Technical Newsletter

By: Technogym After Sales Service

No. 126 – July 2015

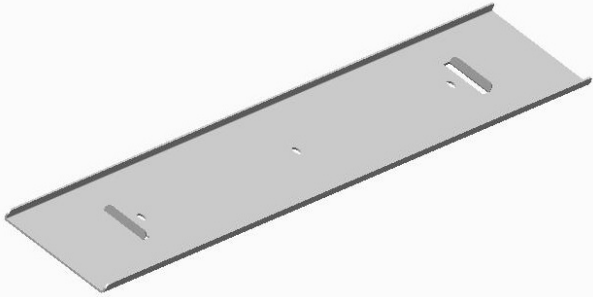
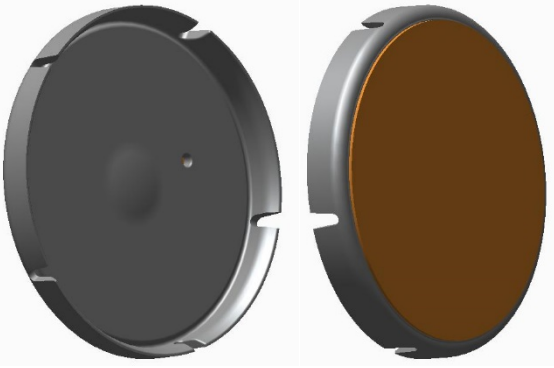
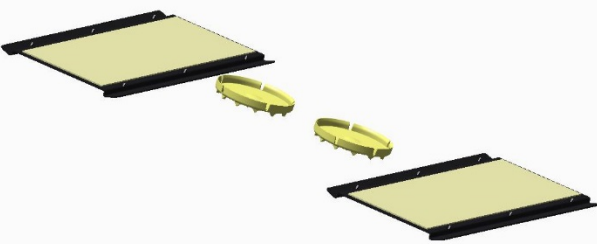
Anti-slip solutions

In the previous newsletter (TN 2015/01), we communicated the code of the new plate **A0000799** to be placed below the rear feet of the machine, so it does not move when training, when used on parquet.

For complete information, the summary table below contains all the solutions that can be used to avoid this problem.

PARQUET FLOORS		
A0000799		To be placed below the rear feet.
Or		
T0000994AA		To be placed below the rear feet.
CARPET FLOORS		
A0000783		The 2 plates must be placed below the front wheels. The caps are to be placed below the rear feet.

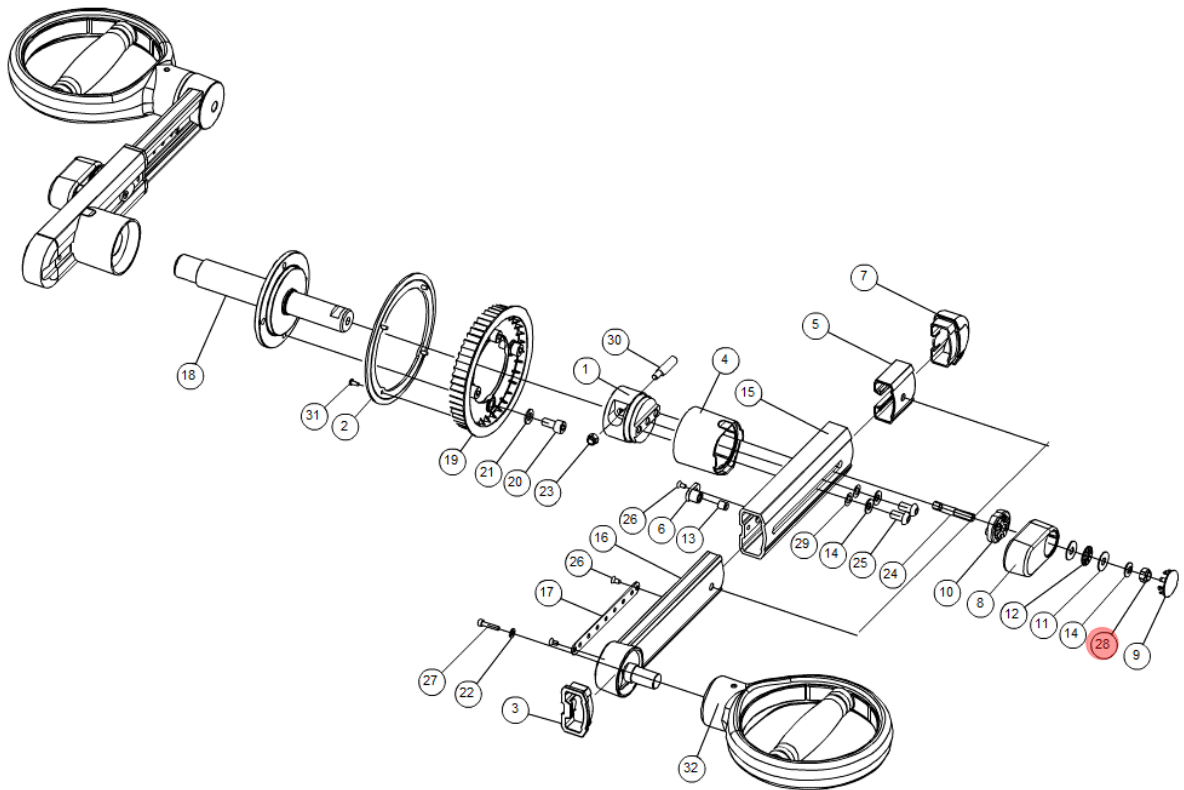
Loosening of the exercise lever adjustment knob

If the knob for blocking the exercise lever loosens it will no longer function properly. The cause is most likely a loose nut **ref.28**.

To keep this situation from repeating itself, apply a drop of Loctite 331 when tightening it.

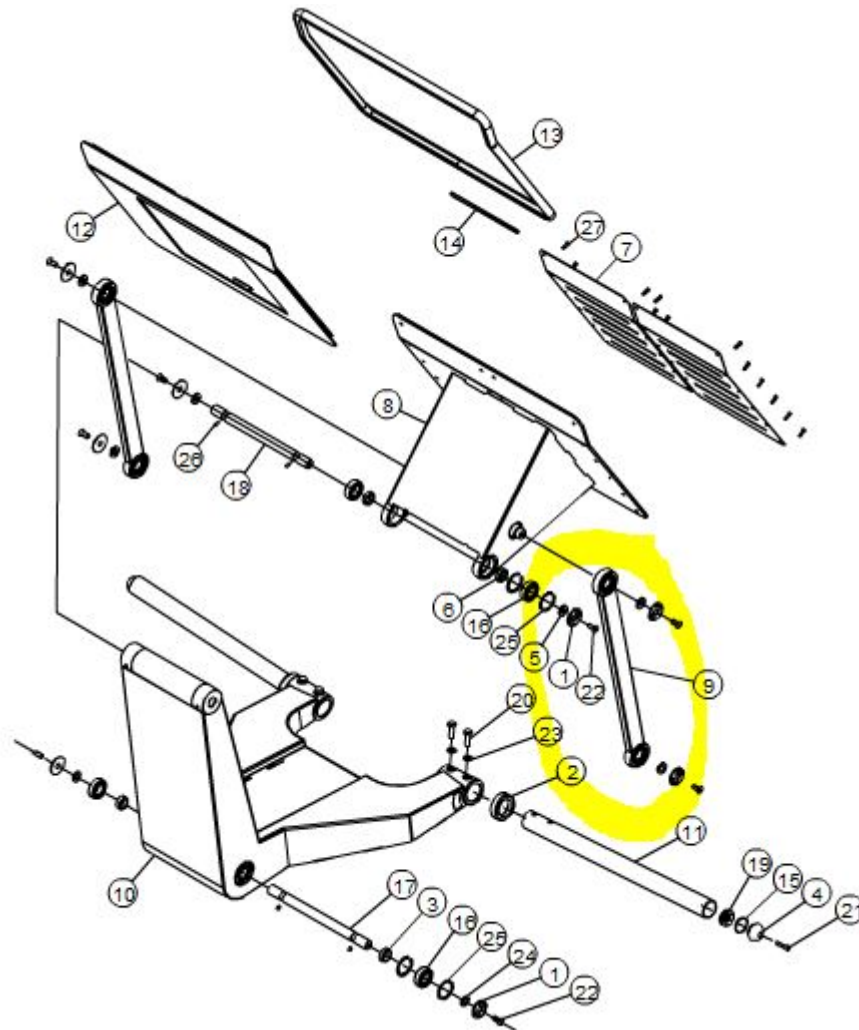
LEG PRESS: change to the foot plate leverage system

The mechanics for the foot plate have been changed, adding an additional symmetric lever to what is shown below, which is already present.

As shown in the figure, the new lever on the right side of the machine is the same as the one already present, and is fastened in the same way.

This solution makes the system stronger and movements more fluid.

The first machine produced with this solution has SN **MG500015100248**.

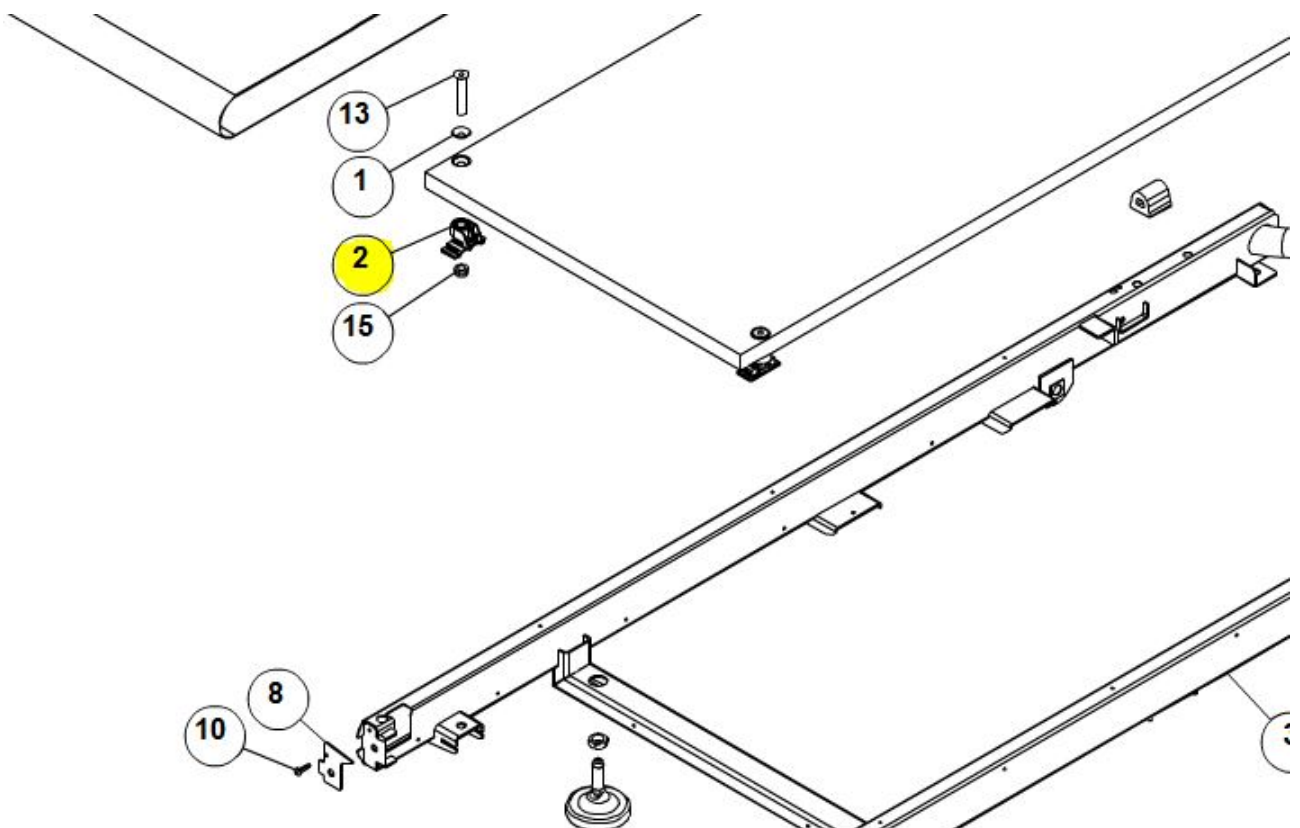
Machine noise due to belt sliding

In the case of machine noise coming from the belt during operation, due to its sliding until it comes into contact with the support spacers on the running deck, we suggest proceeding as follows.

1. Replace the rear roller. A new roller with a slightly modified profile is available which further limits the sliding of the belt during operation.
The code for this new roller, which is fully interchangeable with the previous one, is **T0000582AC**.
2. Replace the belt. The new belt, which has more restrictive tolerances, also limits possible sliding while working out.
The code for this new belt, which is fully interchangeable with the previous one, is **OK001078AA**.
WARNING: this belt must be installed with a tension of 7‰ (7 per thousand)
3. Replace the support spacers from the deck. Smaller spacers (ref. 2 in the figure below) are available that increase the belt movement area by a few mm, in the case of sliding.
The code for these new spacers, which are completely interchangeable with the previous ones, is **OC004226AA-NR**.

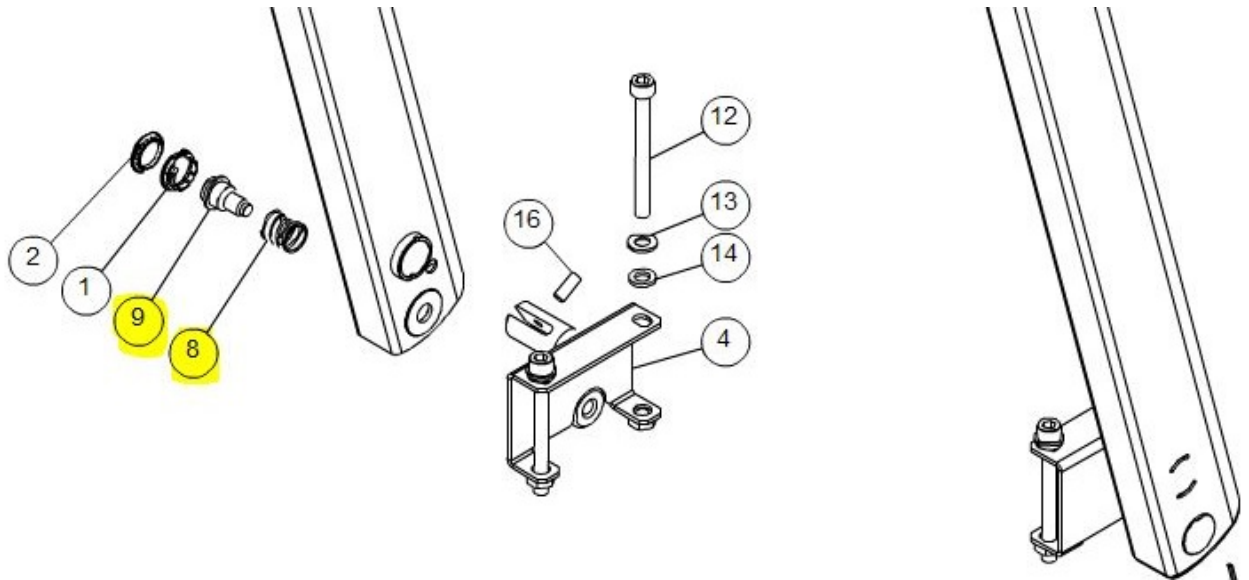
Display pole assembly problems

If it is difficult to assemble the display support poles, first remember that it is important to keep the pole aligned when tightening the first threaded pin.

If it is still not possible to screw the pin into the frame, the pin (ref.9) and the spring (ref.8) can be replaced with the new versions of the same components, which have been changed slightly to make assembly easier.

The new components are interchangeable, but both must be replaced. The codes for the 2 components are indicated below:

REF.	CODE	DESCRIPTION
8	OM000460AB	Spring
9	OP001920AD	Threaded pin
